**Re: Modification Request – Concept Plan Approval for Redevelopment of the Former Allied Mills Site, 2-32 Smith Street, Summer Hill (MP10\_0155 MOD1)**

## Attachment 1: Architectural Drawing Package

View from bridge along Old Canterbury Road (Proposed)

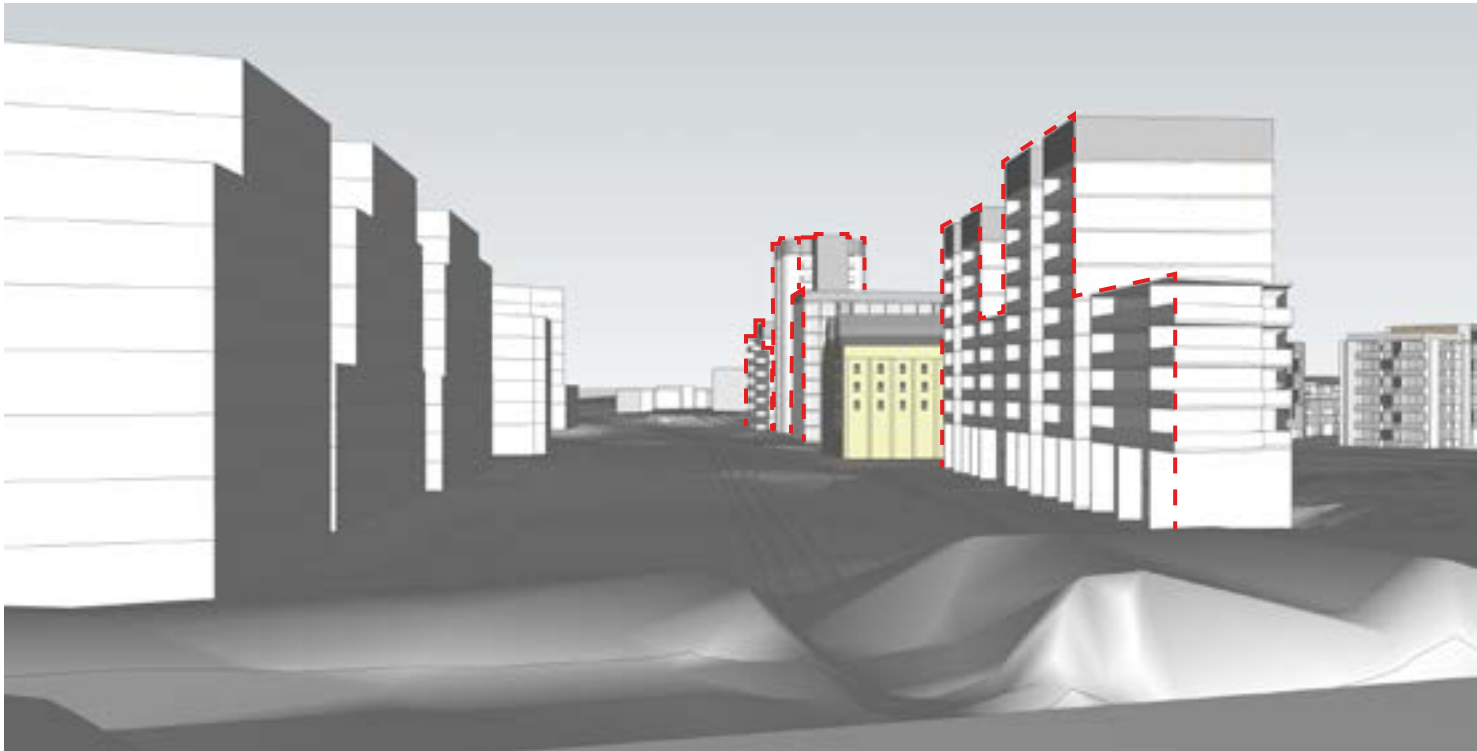
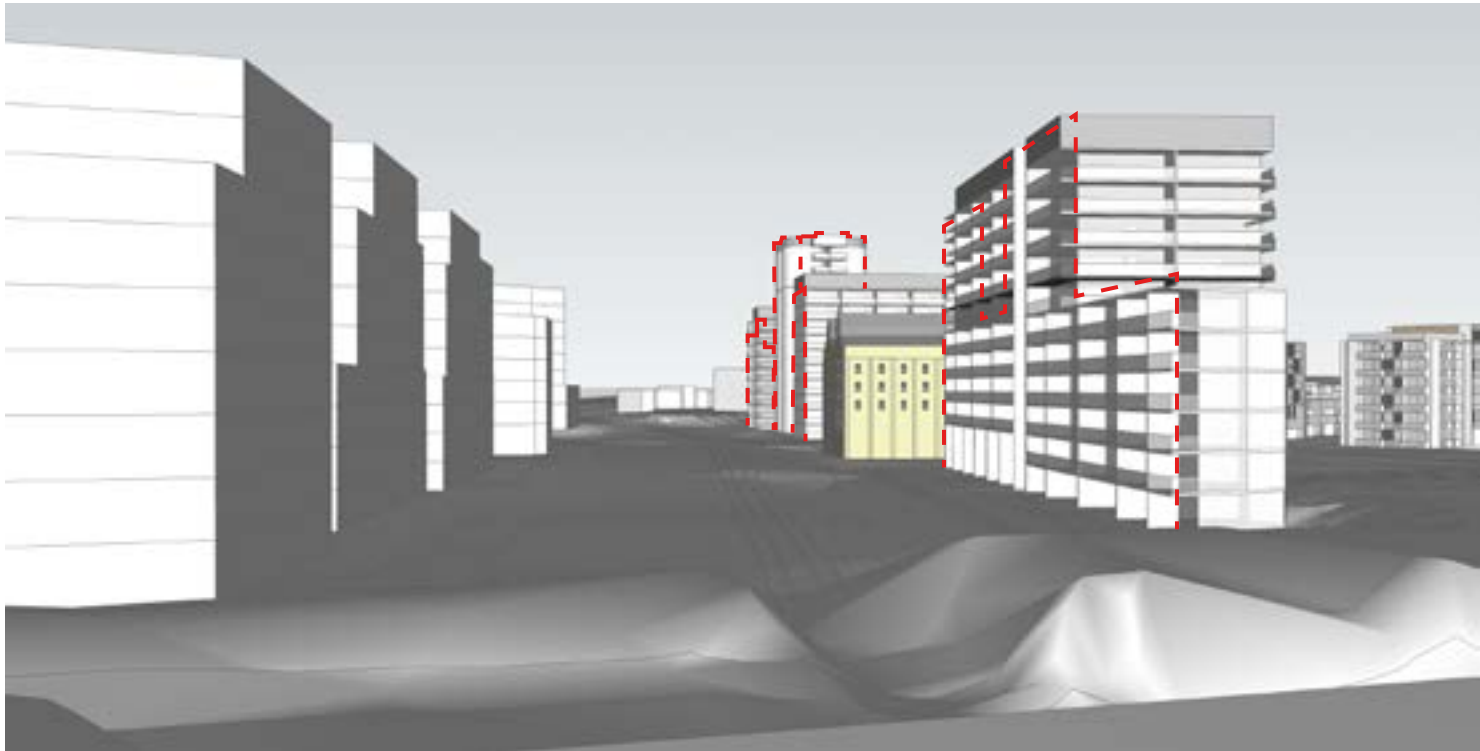
As shown in the design guidelines and visualisations, the proposed height to 47.4m is sought to accommodate a recessed roof plant zone. The parapet level of the building able to be accommodated within the requested envelope would therefore sit between the two (2) current approved top RLs of 44.2m and 47.4m.

The visualisations demonstrate that the relationship between the proposed envelope and the approved envelopes opposite the site are not inconsistent.

**SUMMER HILL FLOUR MILL\_**  
**SUN STUDY - MUNGO SCOTT BUILDING**  
 SHEET 01

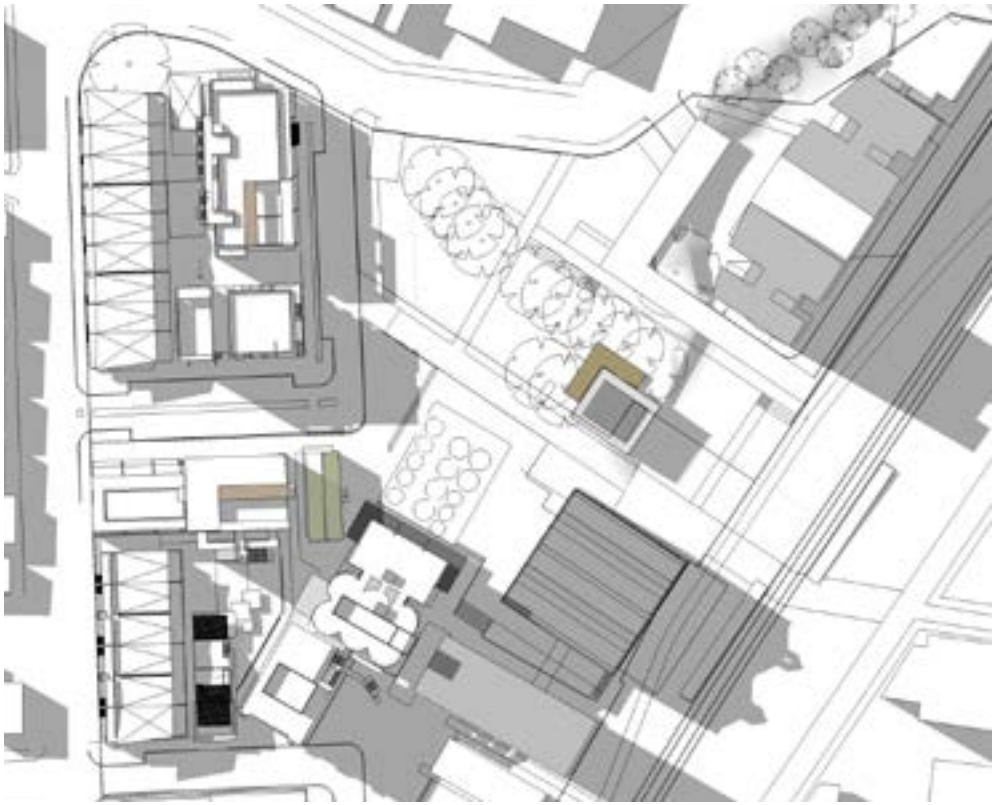
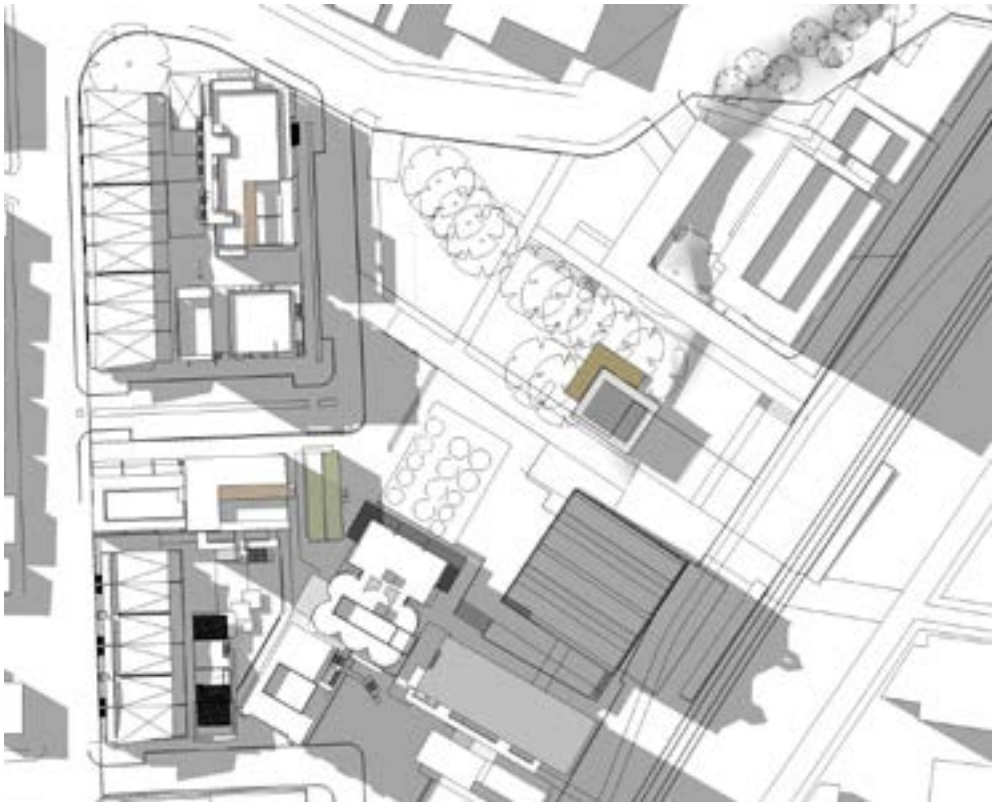
The second element of the assessment of the modification relating to the envelope of Building 1A, concerned solar access impacts, particularly to the Mungo Scott building to the south.

An analysis of the solar access impacts of the approved and proposed envelope of Building 1A has been prepared and is included in the architectural drawing package at Attachment 1. The analysis demonstrates that there is a negligible difference between the approved and proposed envelope on the Mungo Scott building and the open space access through the site.
